**CITY OF MOUNTAIN VIEW
MEMORANDUM**

SUBJECT: MAY 25, 2010 STUDY SESSION—HIGH-SPEED RAIL ALTERNATIVES ANALYSIS

The purpose of this Study Session is to gain Council input on proposed comments from the City to the California High-Speed Rail Authority (CHSRA) on the Preliminary Alternatives Analysis Report (AA) for the High-Speed Rail (HSR) project.

CHSRA/PRP CSS TOOLKIT EXERCISE I

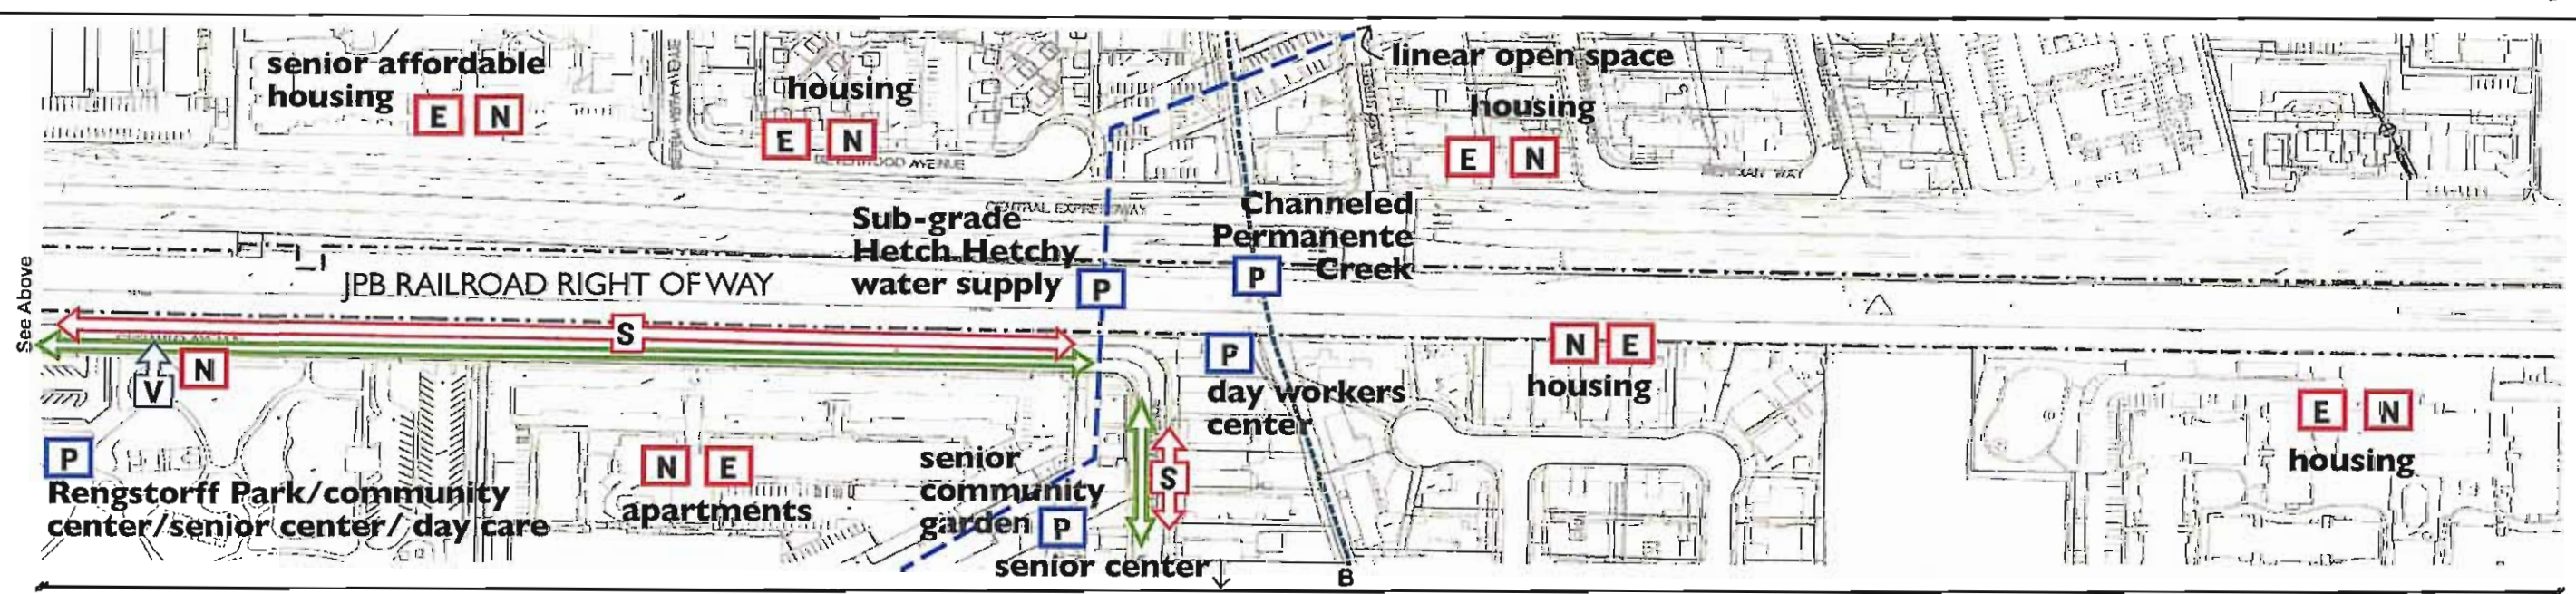
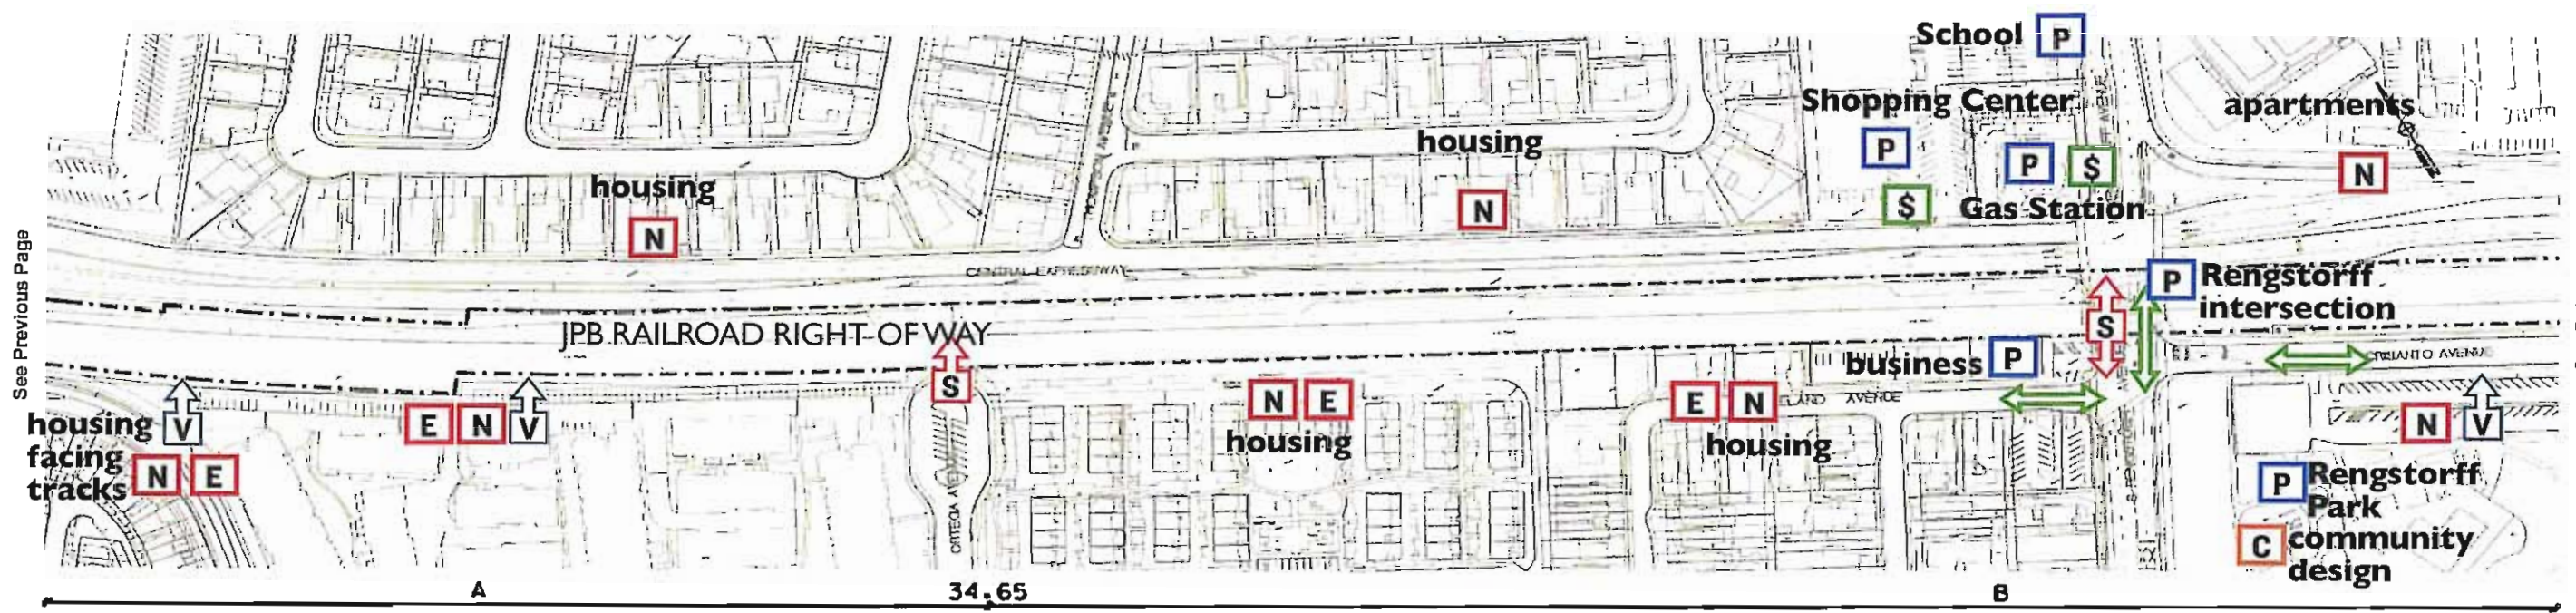
- Safety and connectivity to Rengstorff Park, senior center, senior gardens and day workers' center.
- Conflicts with Permanente Creek culvert and PUC Hetch Hetchy waterpipes.
- Improve safety and connectivity at rail/Rengstorff/Central Expressway intersection.

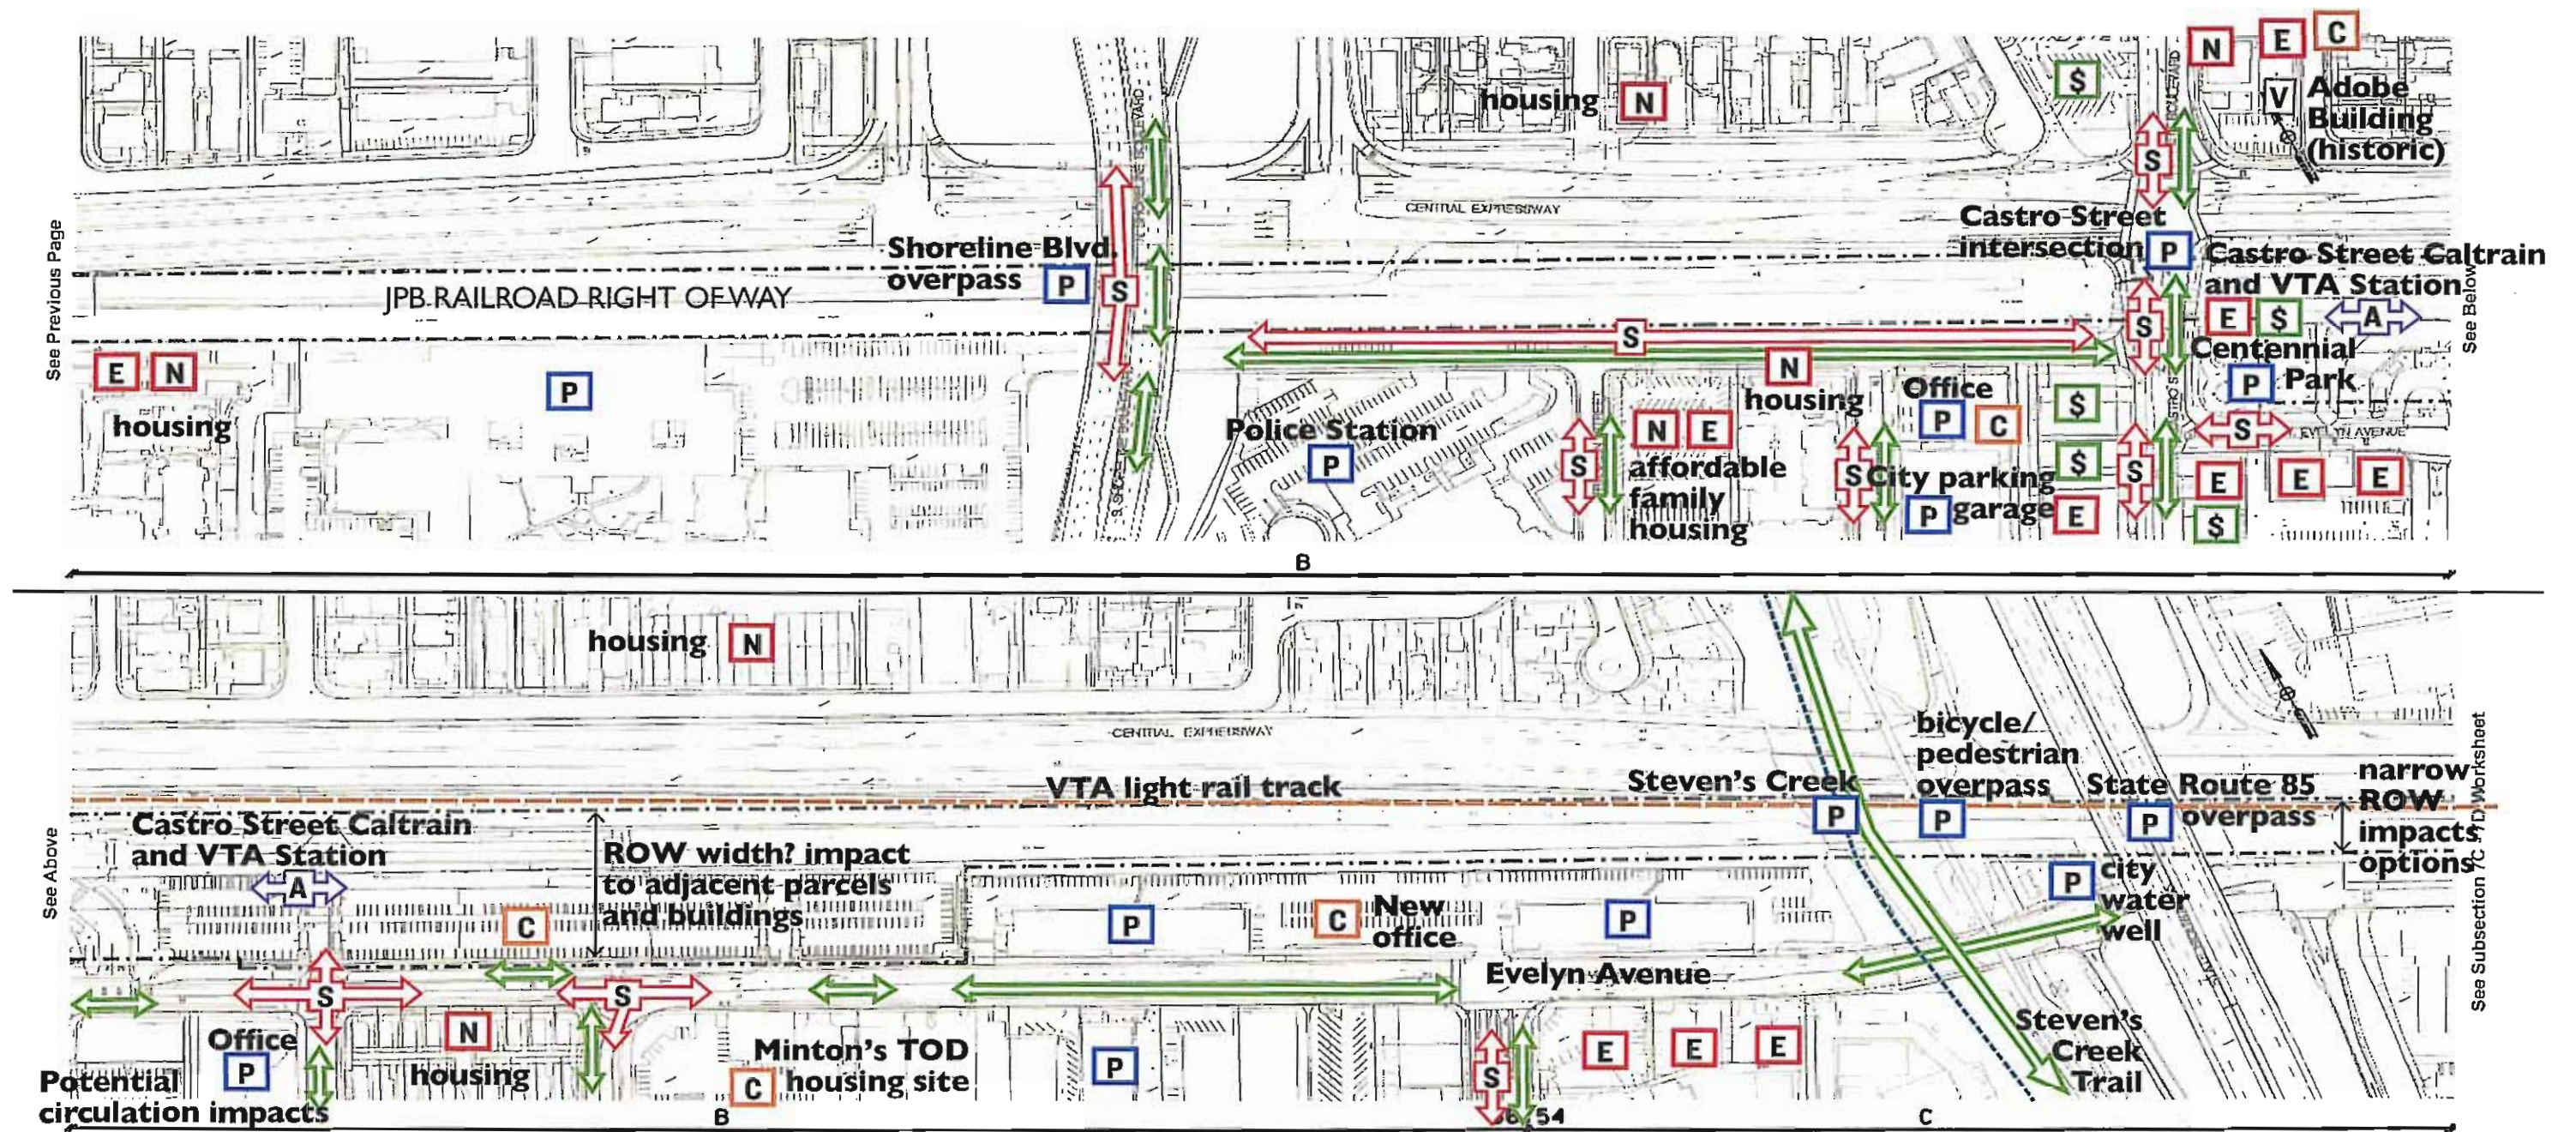
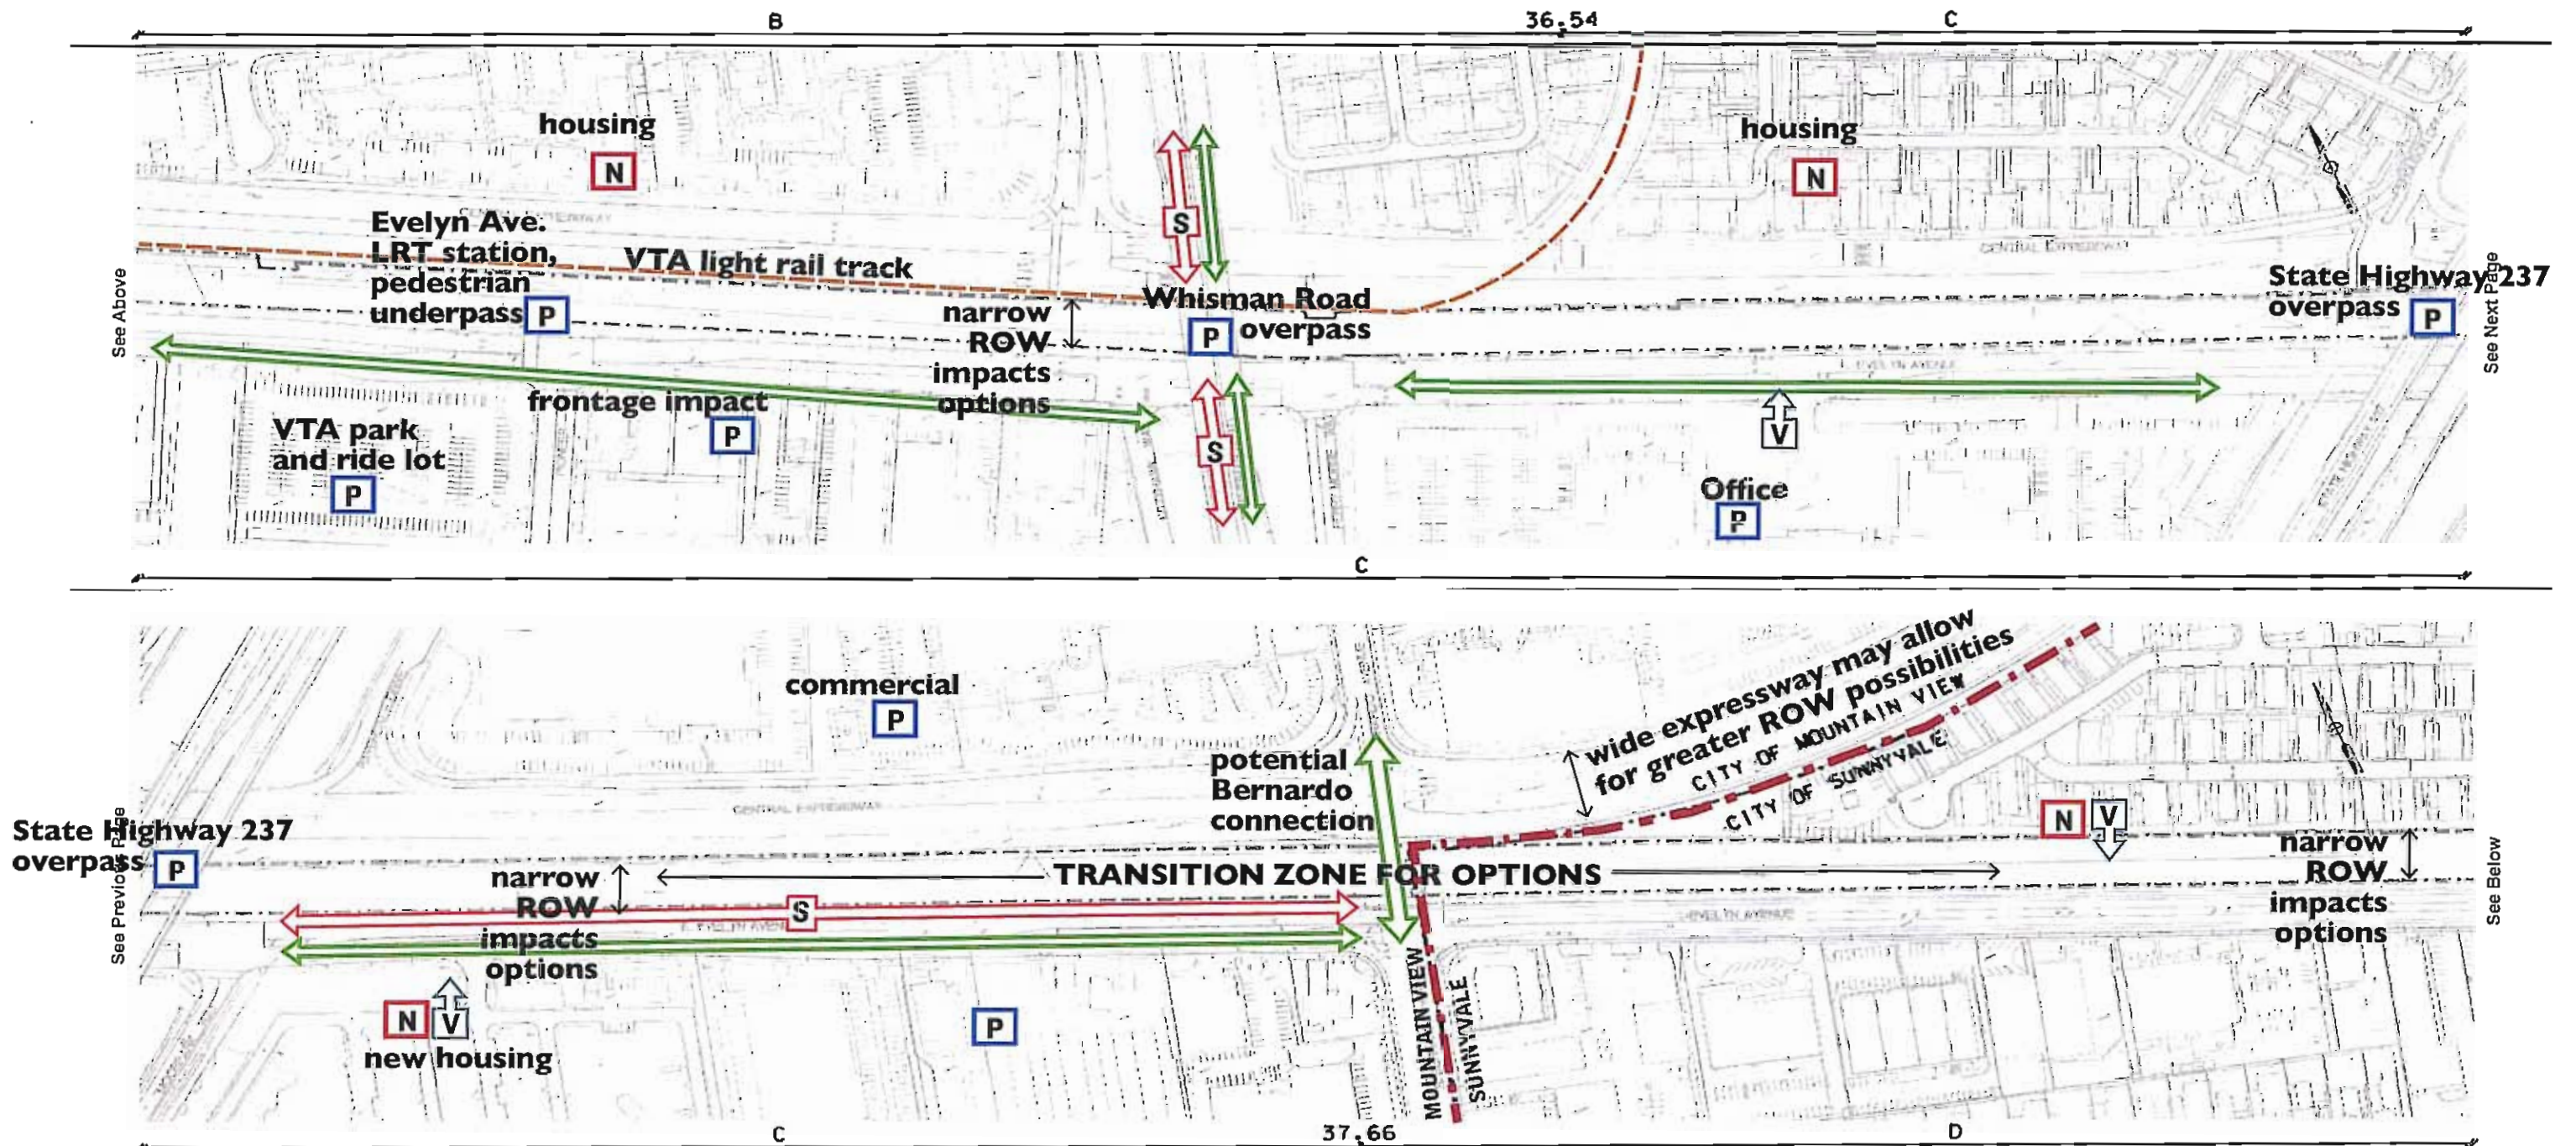
- Better access to and from Caltrain/Light Rail. Historic downtown/Castro Street- visual character, safety, local businesses, maintain accessibility and connectivity.
- Community has a Downtown Precise Plan and an Evelyn Ave. Corridor Precise Plan for this area .
- Major physical impacts to streets, roads and adjacent properties. Major visual impacts, especially from Castro Street. Major connectivity impacts - station area as well as city circulation.
- Major economic vitality impacts, potentially to adjacent properties.
- Maintain the amount of existing parking at Castro Station, opportunity for parking structure.

- Maintain safety and connectivity on Whisman, required.
- How will VTA light rail station/pedestrian underpass integrate with HSR at grade?
- Bernardo - not currently connected over Central Expressway - possible improvement (bike/pedestrian or vehicle).
